**Request for Additional Information No. 463(5280, 5281), Revision 0,
Supplement 2**

U. S. EPR Standard Design Certification

Question 03.07.03-40:**Follow Up to RAI 370, Question 03.07.03-38**

Figure 03.07.03-40-1—Illustration of Impact Zone Criteria

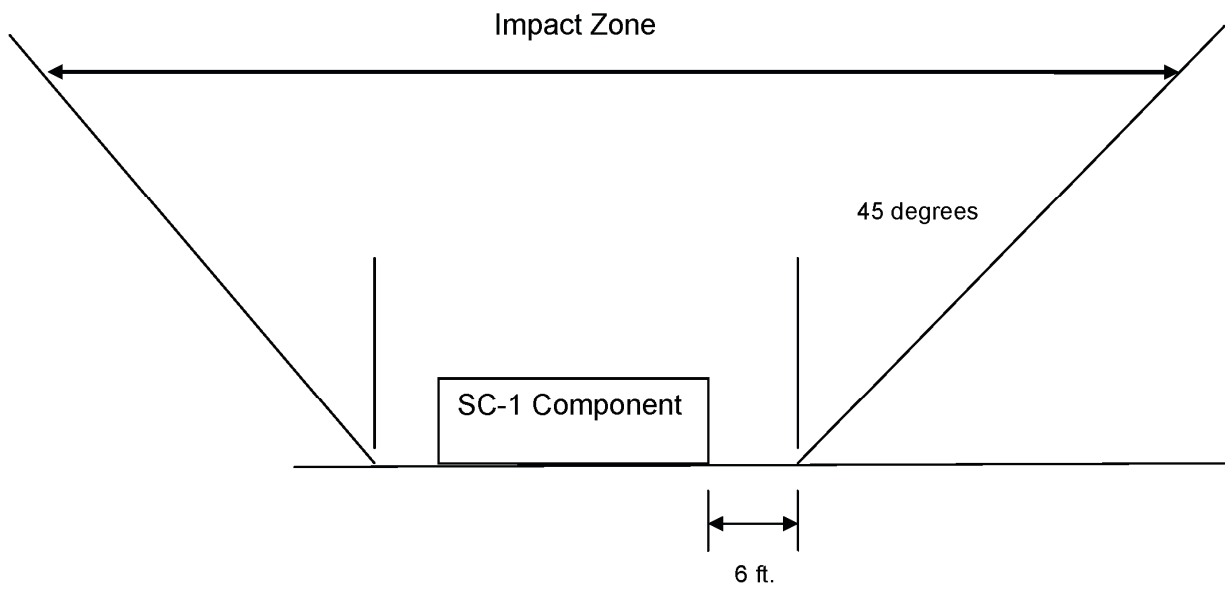
- a. The applicant is requested to provide the basis for assuming a 15 degree impact envelope above the SC I SSC and why this is a conservative assumption.

- a) The 15 degree impact envelope will be revised to include a six-foot buffer around the perimeter of a Seismic Category I component and extending upwards at a 45 degree angle as shown in Figure 03.07.03-40-1. The additional six-foot buffer in conjunction with a 45 degree angle is considered adequate to protect any Seismic Category I component from a missile generated by a 1 g horizontal earthquake load simultaneous with a 1 g combination of vertical earthquake and gravity load.

U.S. EPR FSAR Tier 2, Section 3.7.3.8.2 will be revised to add the impact zone criteria.
